RE: **Holly Senior Living**
9100 Holly Ave NE
Conceptual Grading and Drainage Plan
Engineer's Stamp Date: 1/29/19
Hydrology File: C20D079

Based on the submittal received on 2/4/19, this project is reapproved for Site Plan Building Permit.

CONCEPTUAL
GRADING AND
DRAINAGE PLAN

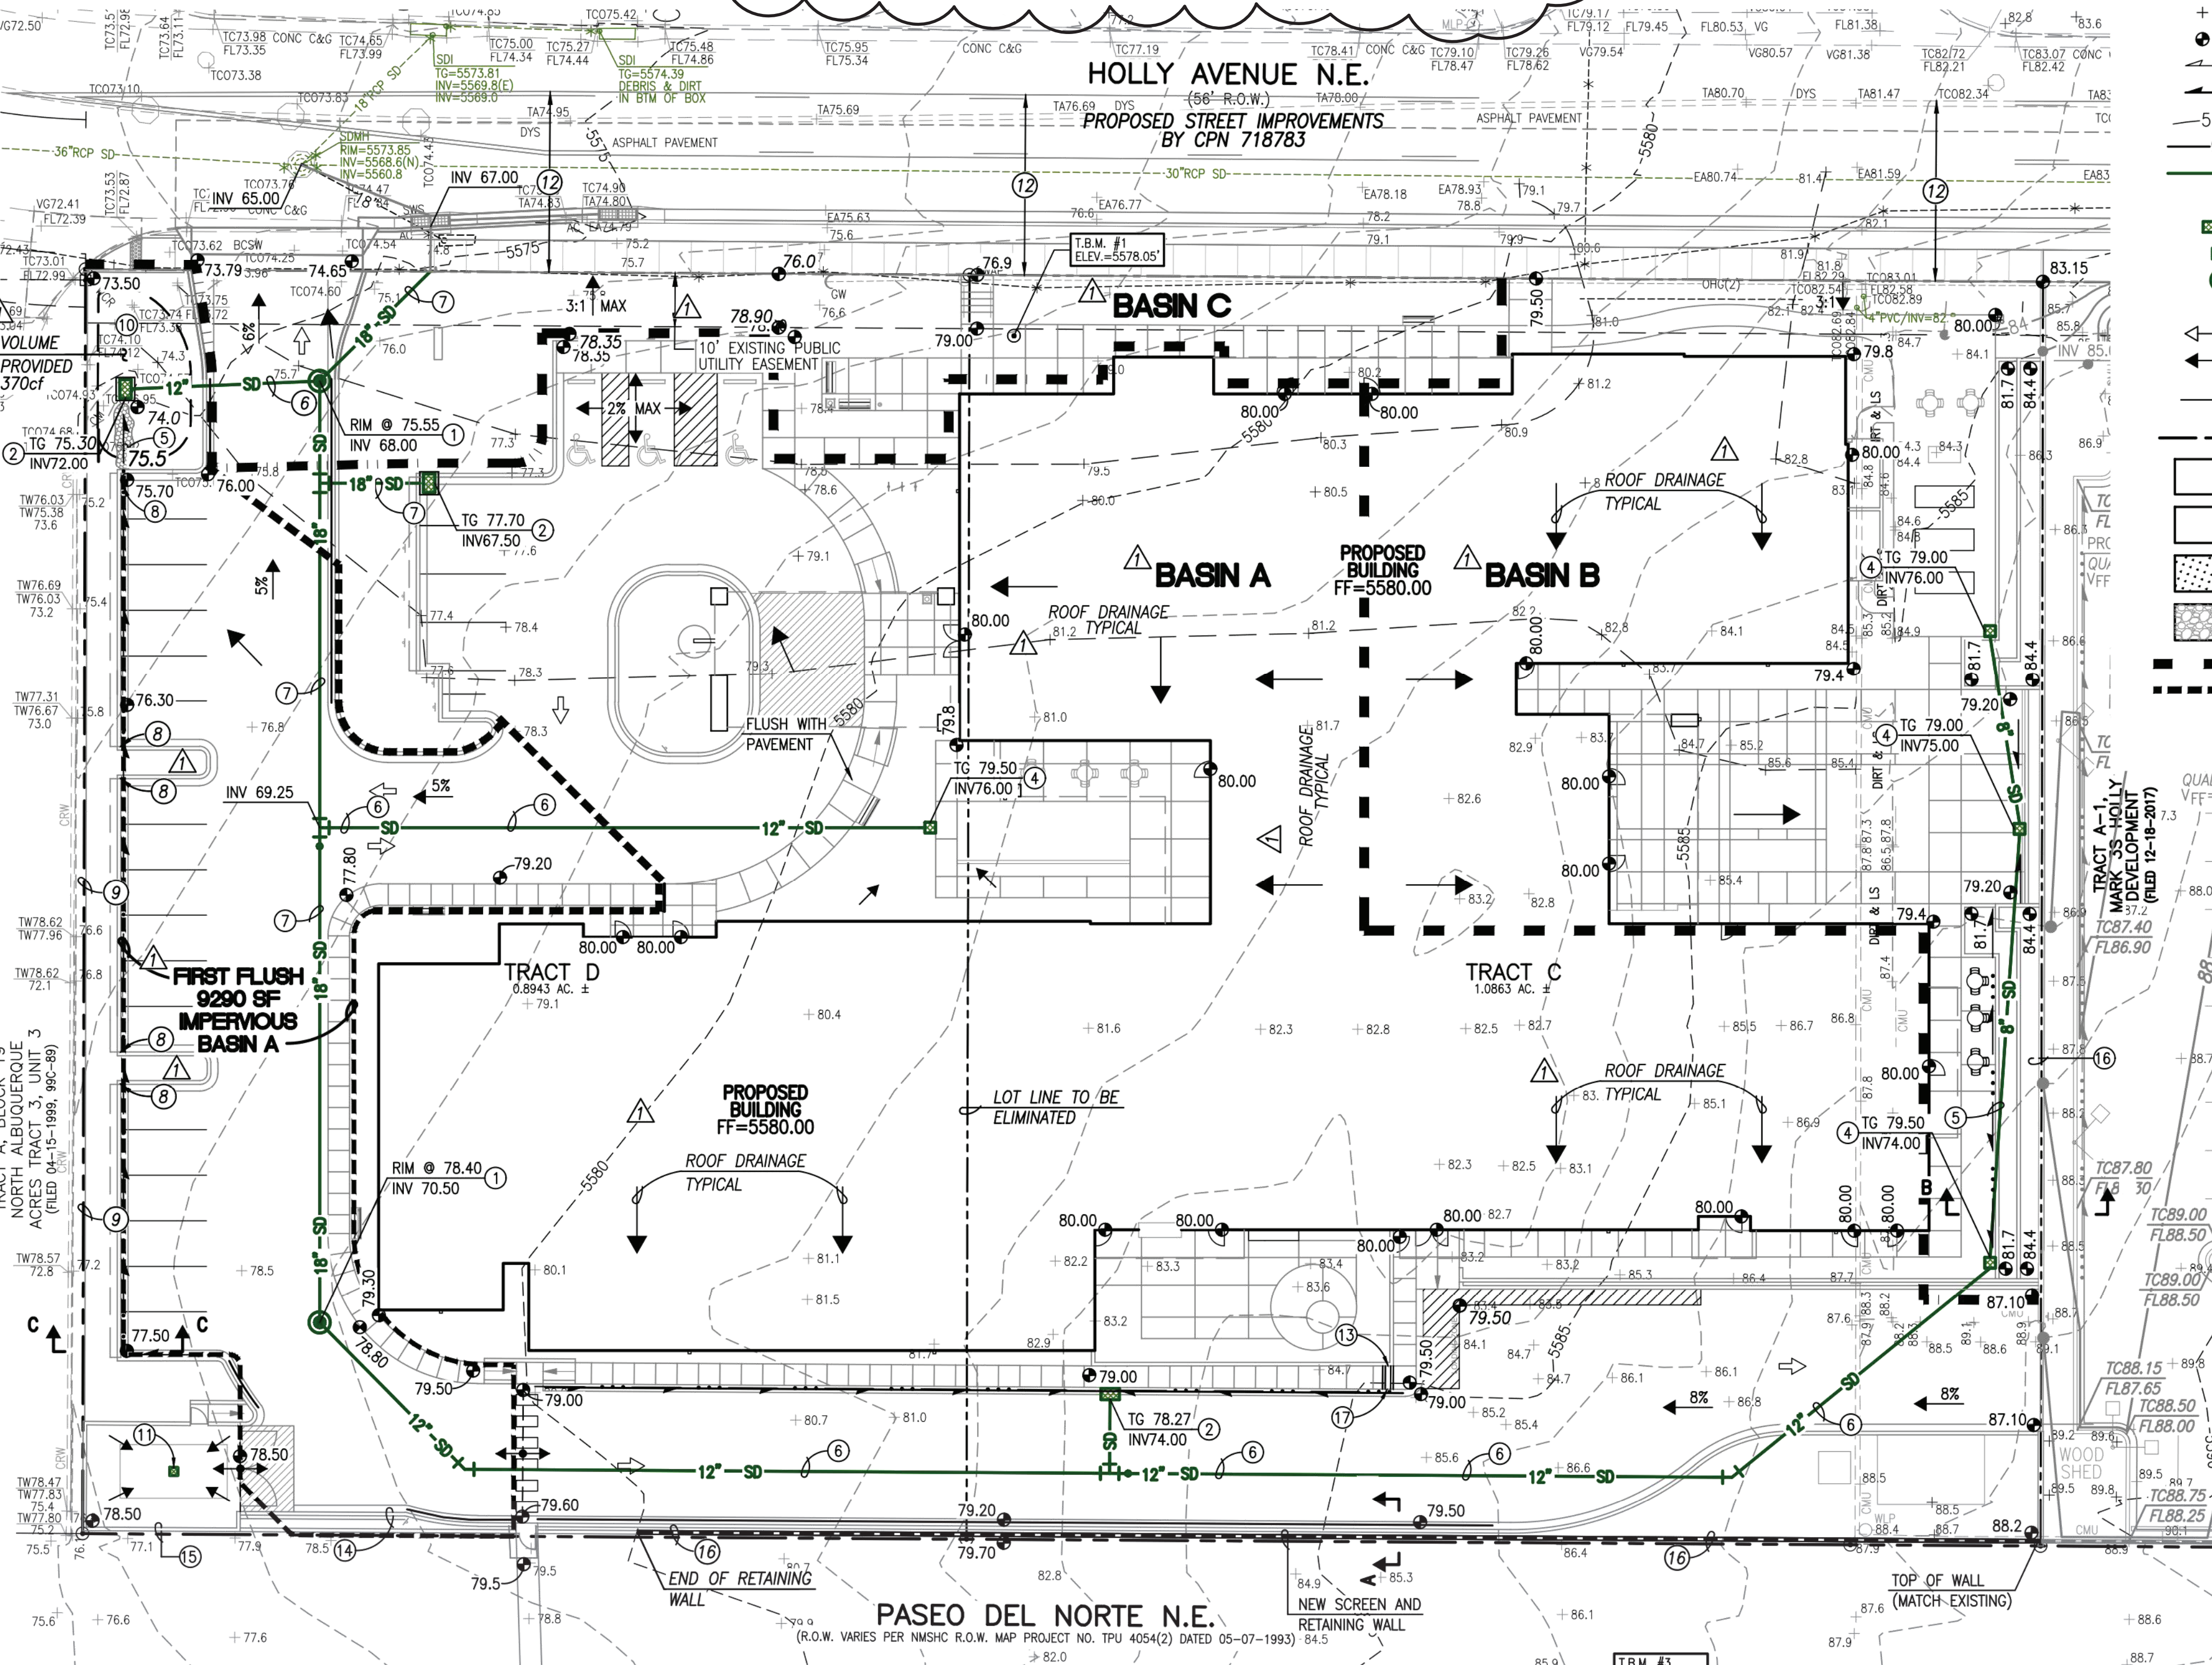
1. Remove all "Conceptual" markings.
2. Hydraulic Calculations are required per DPM 22.3 documenting pipe capacity, overland flowpath capacities, pond routing and water surface elevations for the first flush and the 100-year volumes.
3. This project requires an ESC Plan, submitted to the Stormwater Quality Engineer (Curtis Cherne PE, ccherne@cabq.gov or 924-3420).
4. Payment of the Fee in Lieu (Amount = TBD) for the required stormwater quality volume must be made; provide updated calculations using 0.34"/12, not 0.44"/12 as the basis for determining this volume. Because the initial application for this project was made prior to enacting the current drainage ordinance (Council Bill C/S O-18-2) Fee-in-Lieu of managing the stormwater quality volume may be accepted for this project as presented. Applications made after 10/2/18 are required to comply § 14-5-2-6 (H) of the new ordinance.
